GRADING AND EROSION CONTROL PLAN

MARCH 2020

EROSION CONTROL PLAN

GRADING DETAILS SHEET

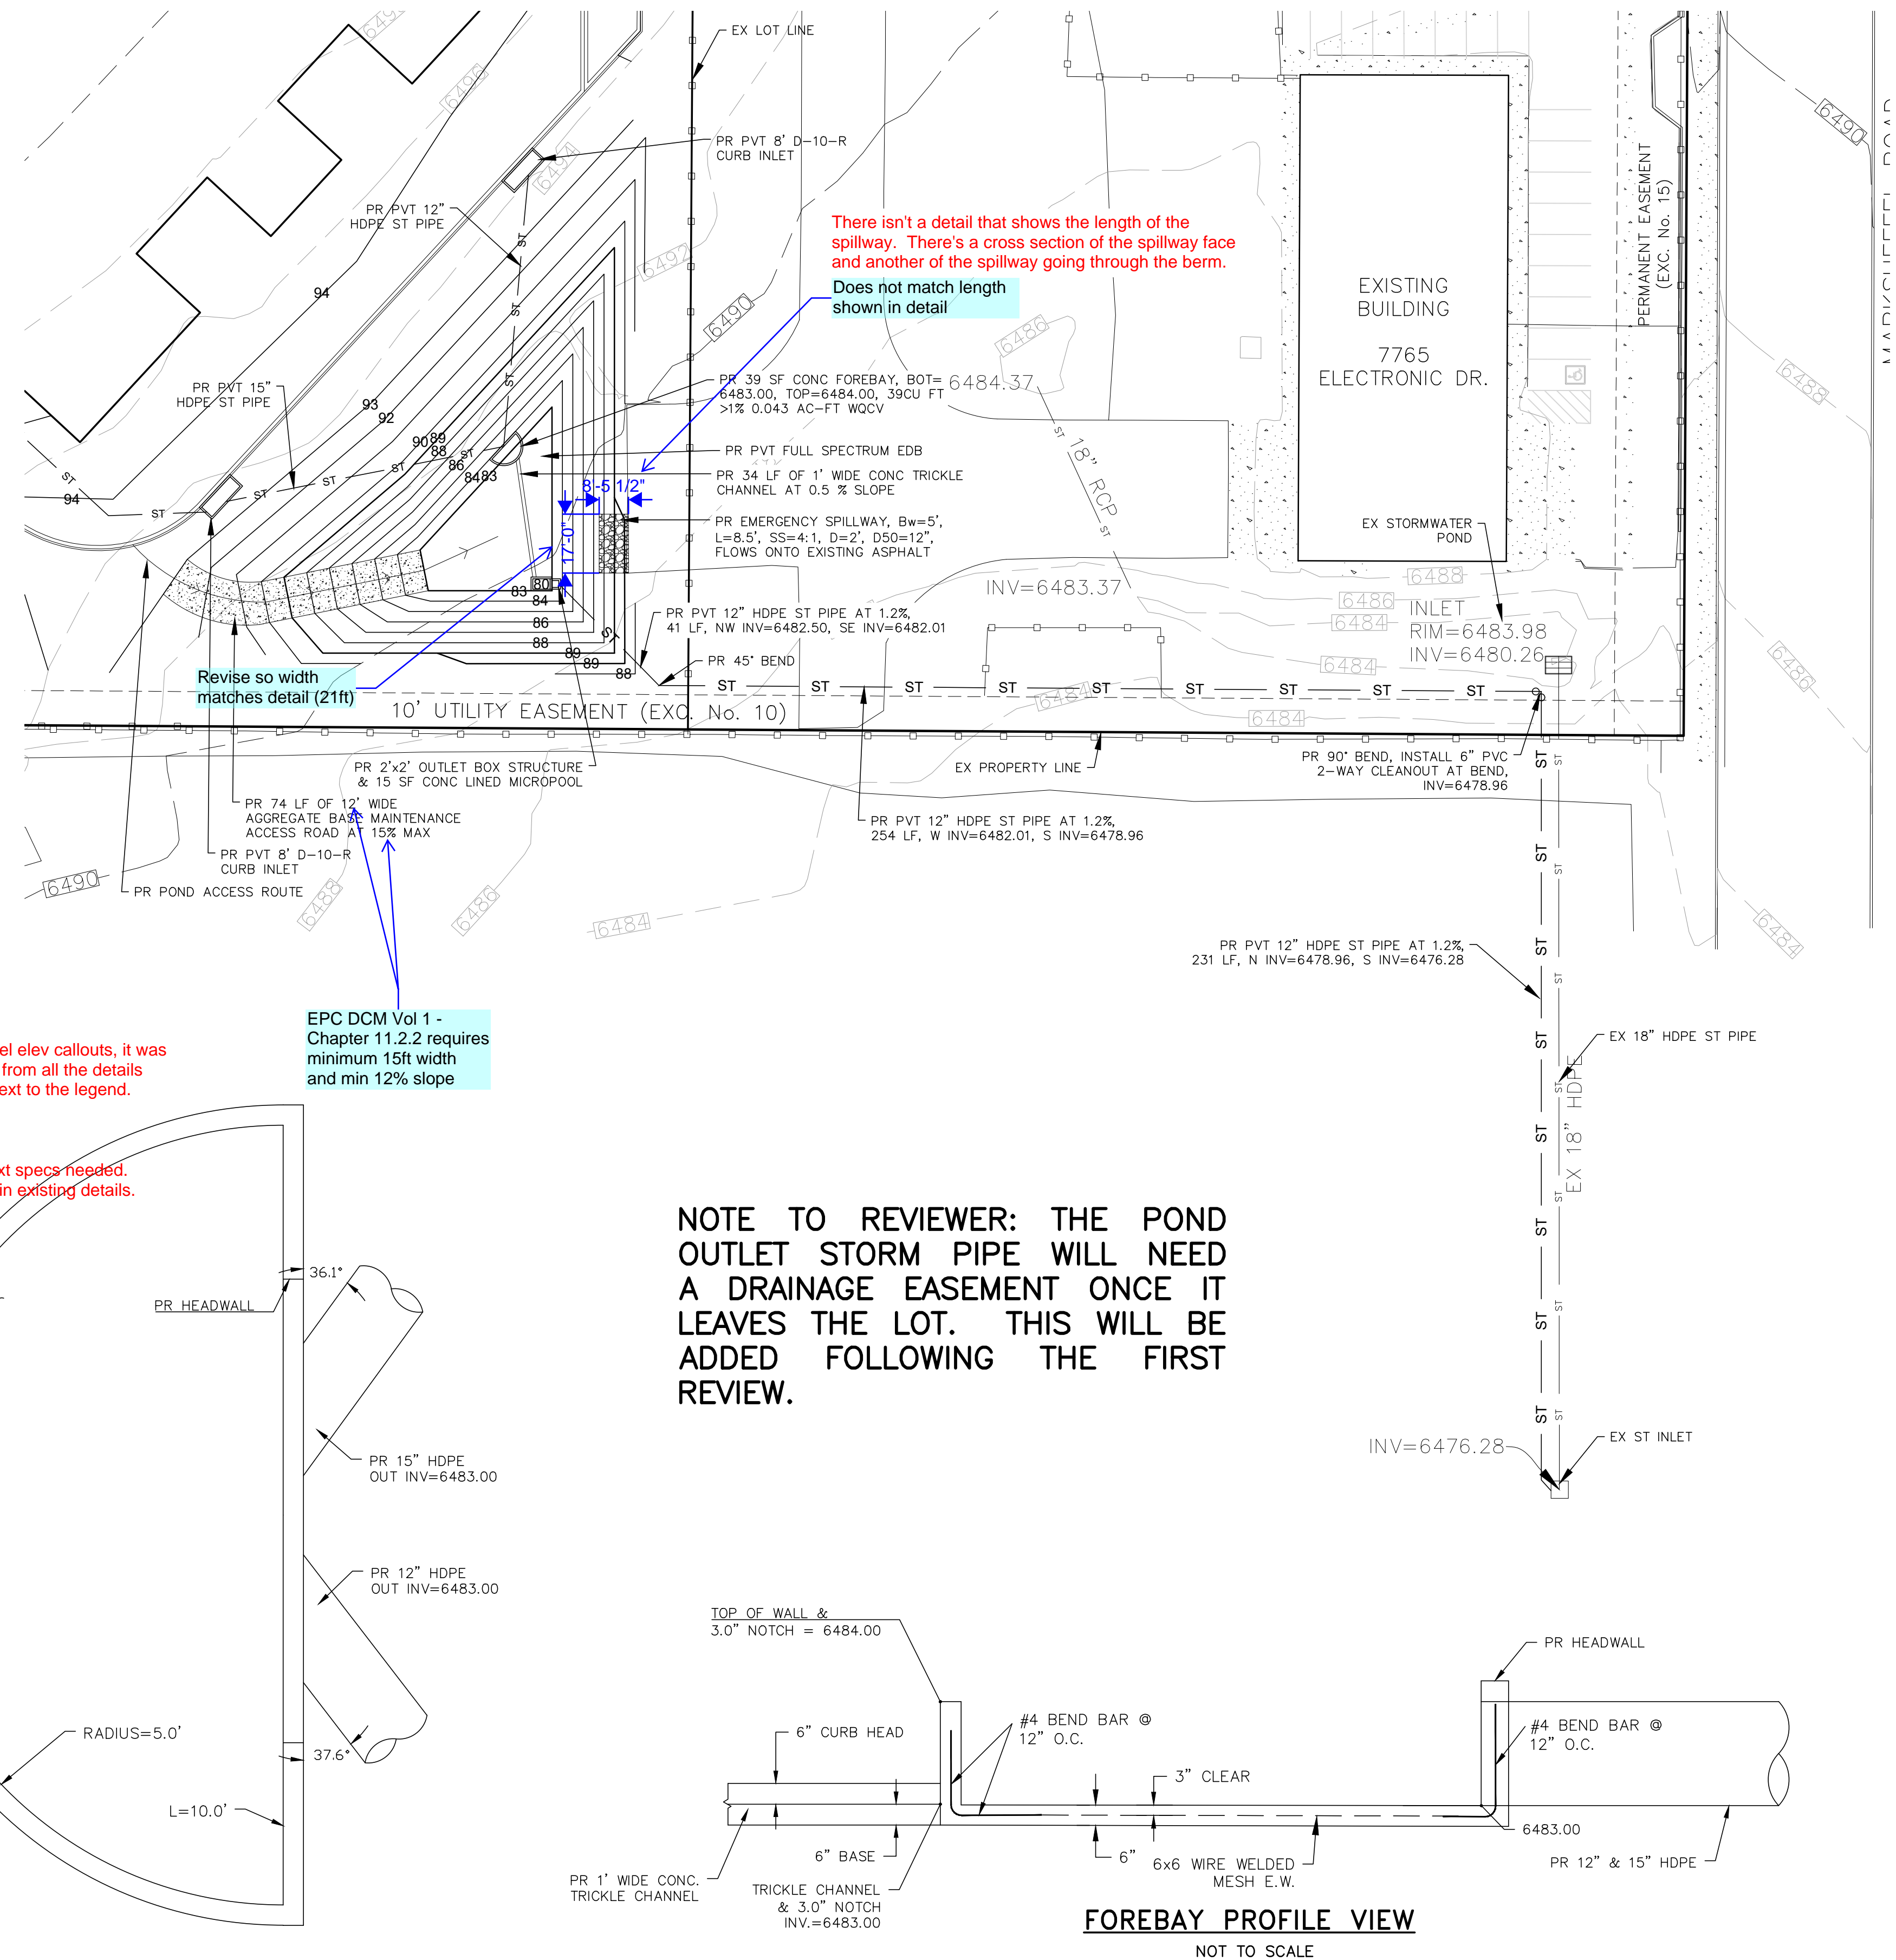
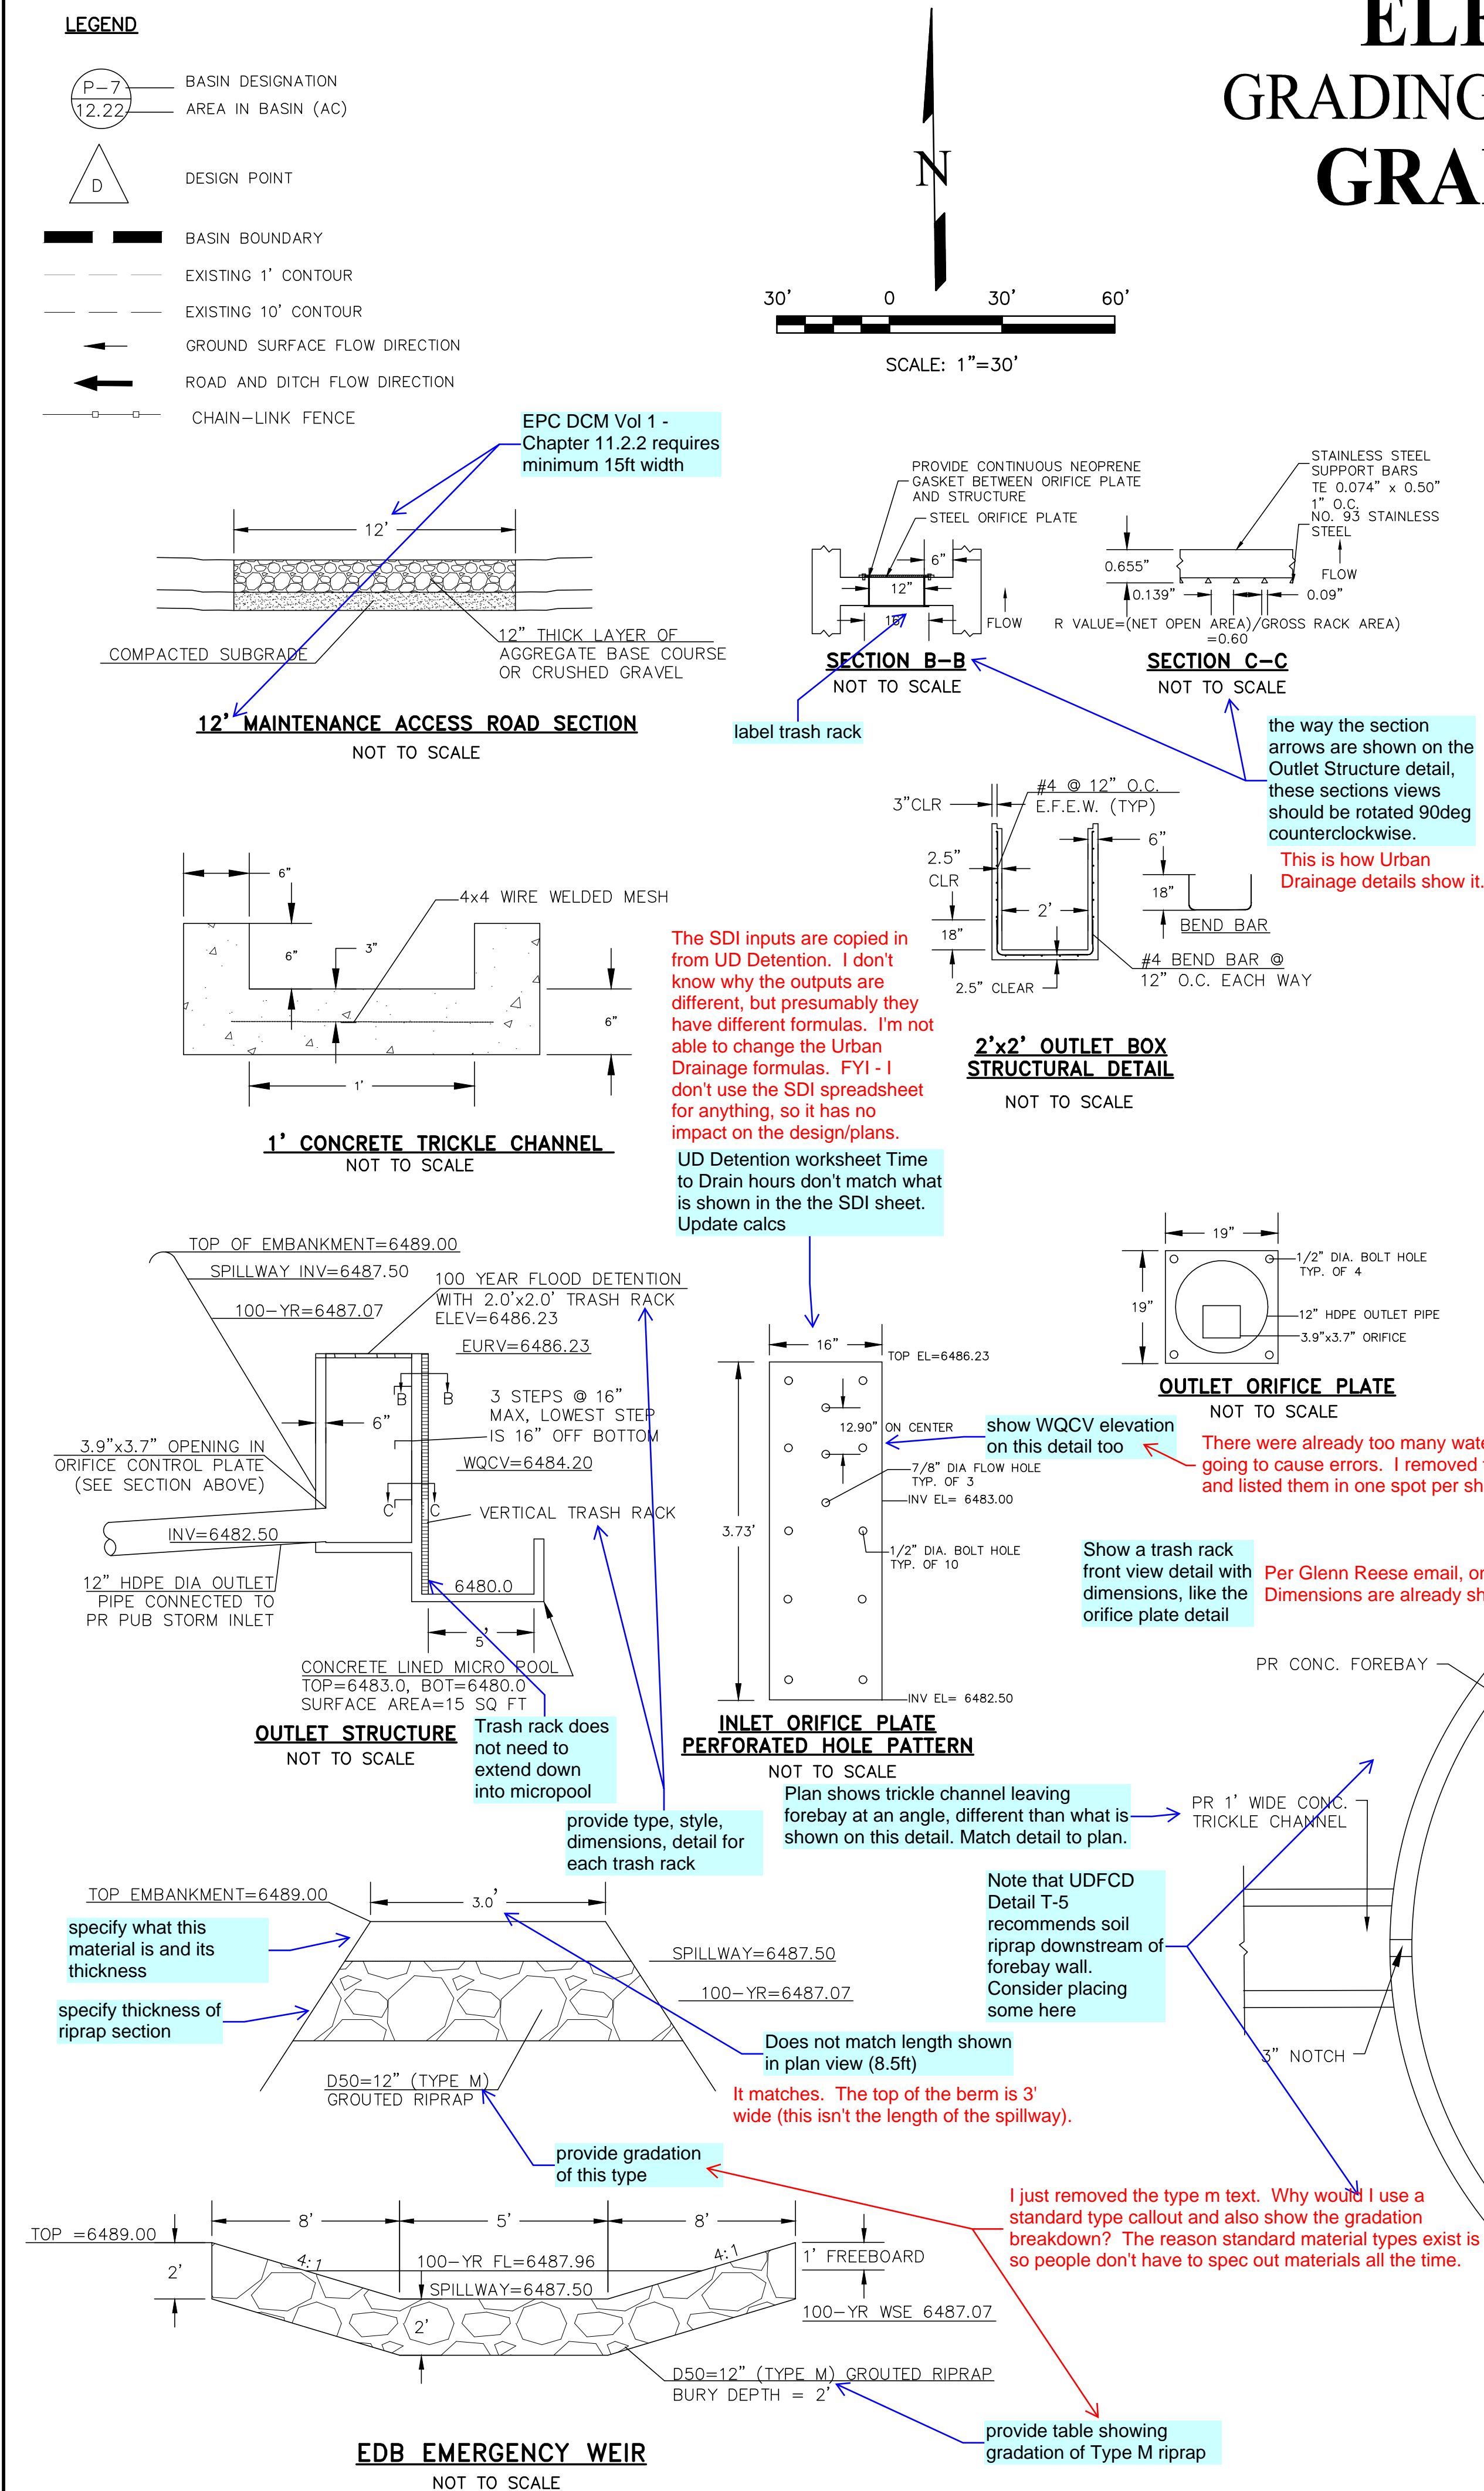
NOTE TO REVIEWER: THE POND
OUTLET STORM PIPE WILL NEED
A DRAINAGE EASEMENT ONCE IT
LEAVES THE LOT. THIS WILL BE
ADDED FOLLOWING THE FIRST
REVIEW.

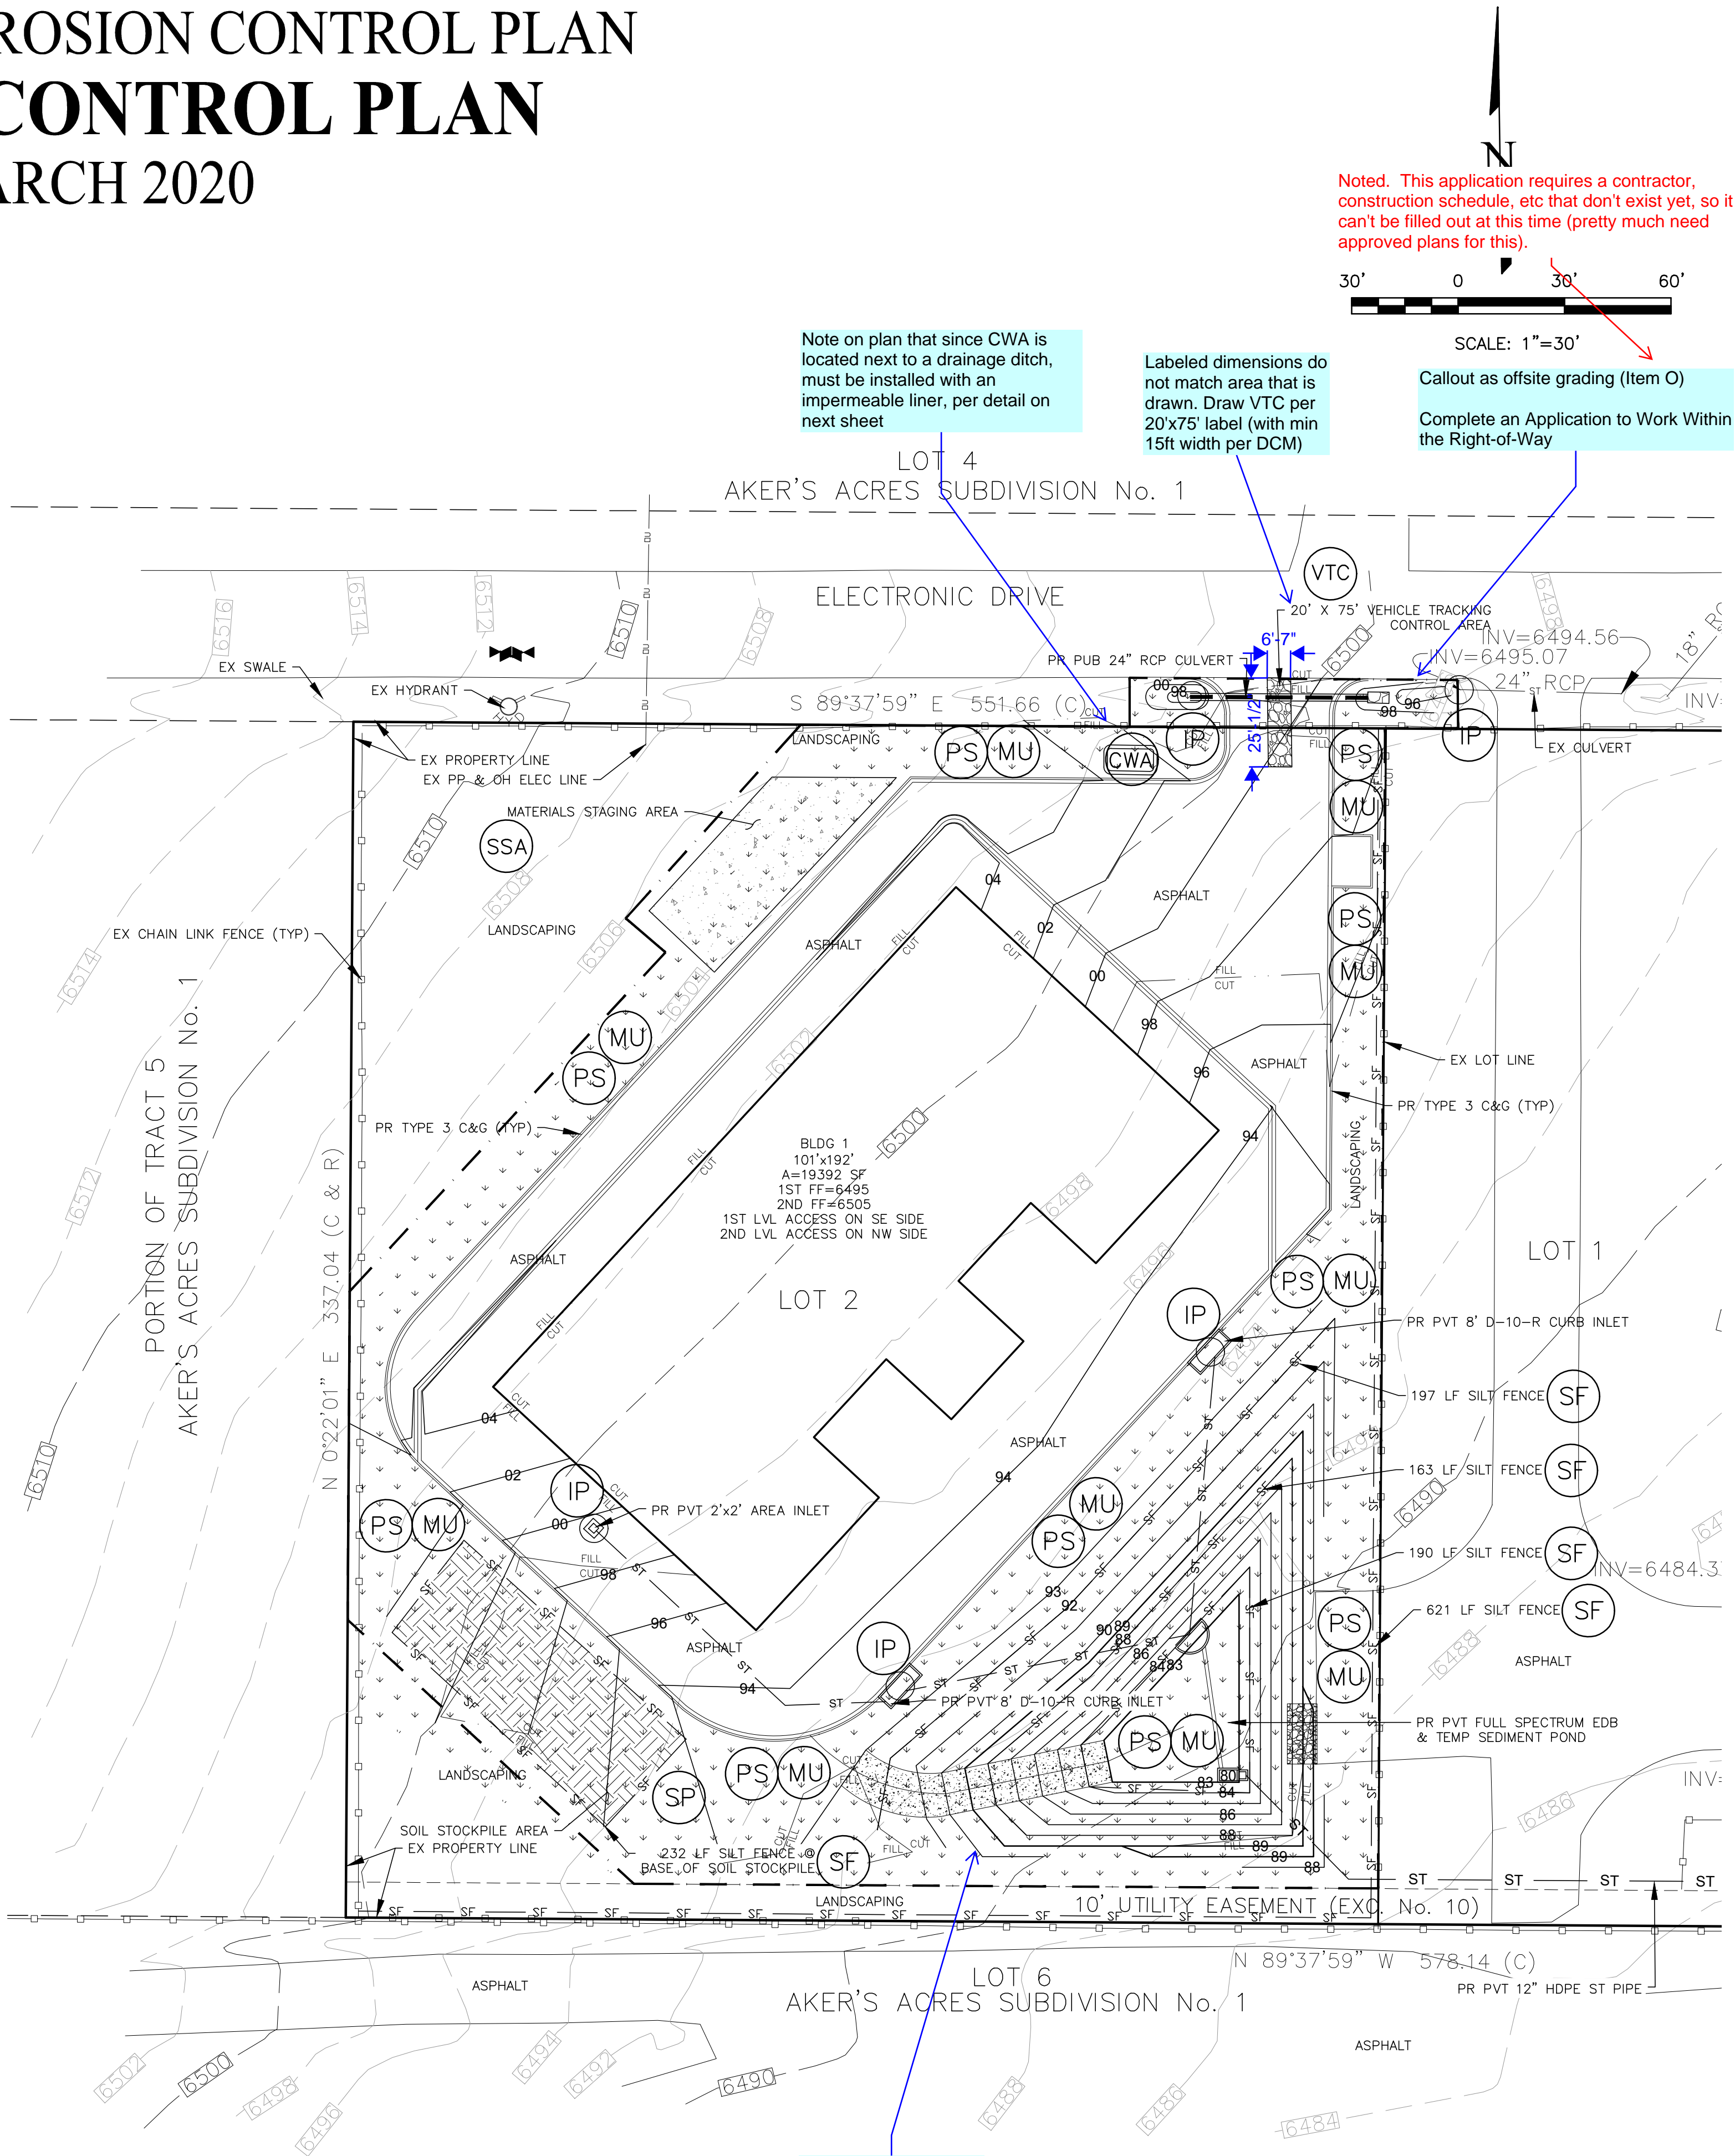
Item O - add a note discussing conditions of offsite grading near site entrance.

Include origin of information (ex: visual inspection). Note that the drainage report states that there is "mostly grasses and dirt surfaces, and a small number of trees." Revise note to match drainage report.

Show location of waste container, portable toilets, and SWMP storage location.

SWMP references possible construction trailer. If applicable, show location on drawings.

If locations of any of the above are TBD, don't need to show on drawing for next submittal.

Callout as offsite grading (Item O)
Complete an Application to Work Within the Right-of-Way

Note on plan that since CWA is located next to a drainage ditch, must be installed with an impermeable liner, per detail on next sheet

Labeled dimensions do not match area that is drawn. Draw VTC per 20'x75' label (with min 15ft width per DCM)

Need to show easement around pond

All TBD. Added a note.

Noted. This application requires a contractor construction schedule, etc that don't exist yet, so it can't be filled out at this time (pretty much need approved plans for this).
